**QUESTIONS FROM BIDDERS**  
**WATER TREATMENT PLANT ALUM SLUDGE DEWATERING FACILITY**  
**FOR**  
**CITY OF ROCK HILL, SC**

**W&S Project No. 056-21-120**

**Bid Date: THURSDAY JANUARY 25, 2024 @ 10:00 AM**

PIPING PLAN - TWO

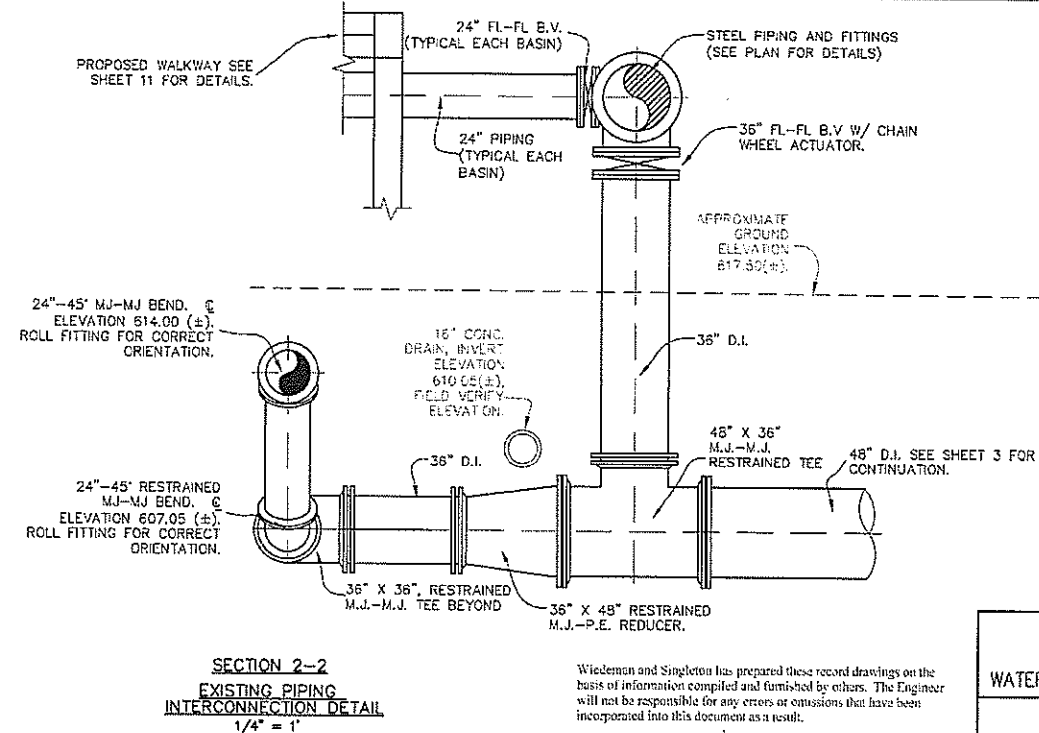
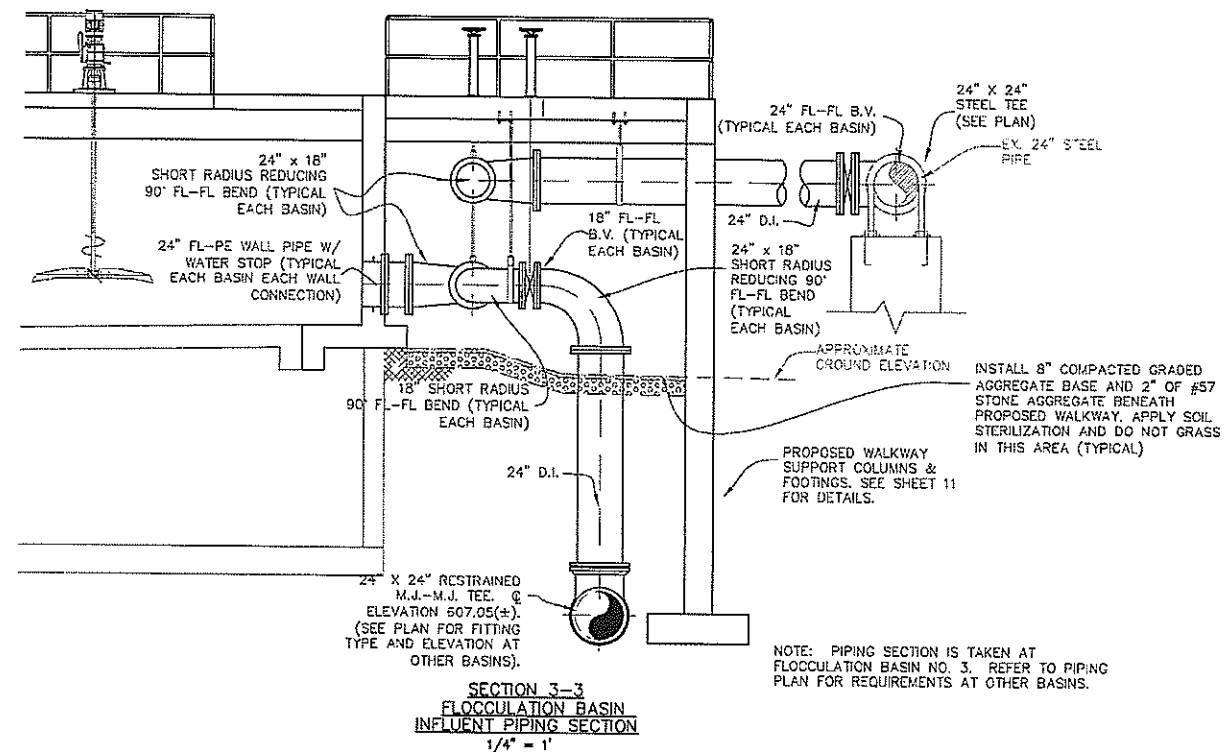
| <b>Question #</b> | <b>Question</b>  | <b>Answer</b>  |
|-------------------|--|--|
| 51                | Please provide the as-builts for the Sedimentation Basin Supply piping. C.01 appears to show multiple pipes stacked on top of each other and 6.MS.01 the piping is obscured by the concrete deck. We cannot see the changes in elevation to quantify.  | The piping is available for inspection and confirmation of the dimension/area of pipe to be painted for the bid, but attached for information purposes only are drawings of only the aerial piping to the basins that is concealed by the slab. These drawings haven't been confirmed in the field.  |
